Access Compliance Report Public Rights-of-Way (Curb Ramps)

Main Street: CROWN_VALLEY_PKWY Cross Street: O_NEILL_DR Location: NW

ADA ID: RPRK211025132344 Ramp Type: Type 4 - Parallel Initial Pass/Fail: Fail Overall Compliance: No Severity Score: 16

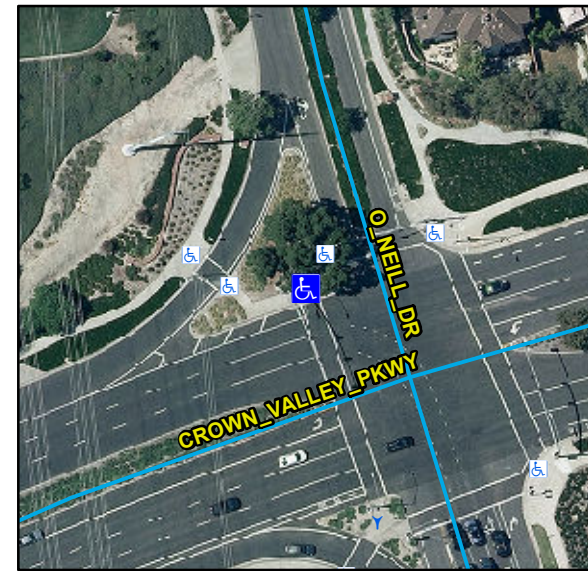
R204.3, R304.3.2, R304.5.3, STD 1115

Compliance	Description	Data	Compliance	Description	Data
N/A	Ramp Length LT (in)	122	N/A	Ramp Length RT (in)	118
Yes	Ramp Width LT (in)	81	Yes	Ramp Width RT (in)	81
Yes	Ramp Run Slope LT (%)	2.2	No	Ramp Run Slope RT (%)	9.8
Yes	Ramp Cross Slope LT (%)	1.1	No	Ramp Cross Slope RT (%)	4.2
N/A	Landing Present	N/A	N/A	DWS Provided	N/A
N/A	Landing Length (in)	N/A	N/A	DWS Contrast	N/A
N/A	Landing Width (in)	N/A	N/A	DWS Length (in)	N/A
N/A	Landing Run Slope (%)	N/A	N/A	DWS Full Width	N/A
N/A	Landing Cross Slope (%)	N/A		DWS Offset Type	N/A
N/A	Landing Movement Obstructed?	N/A	N/A	DWS Offset Left (in)	N/A
	Landing Movement Type	N/A	N/A	DWS Offset Right (in)	N/A
N/A	Landing Shared	N/A			
N/A	Clear Space	N/A			
N/A	Clear Space To Crosswalk (in)	N/A			
N/A	Marked Crosswalk 1	Yes	N/A	Marked Crosswalk 2	N/A
	Crossing 1 Direction	S		Crossing 2 Direction	N/A
	Marked Crosswalk 1 Width (in)	144		Marked Crosswalk 2 Width (in)	N/A

Remove & Replace Entire Ramp.
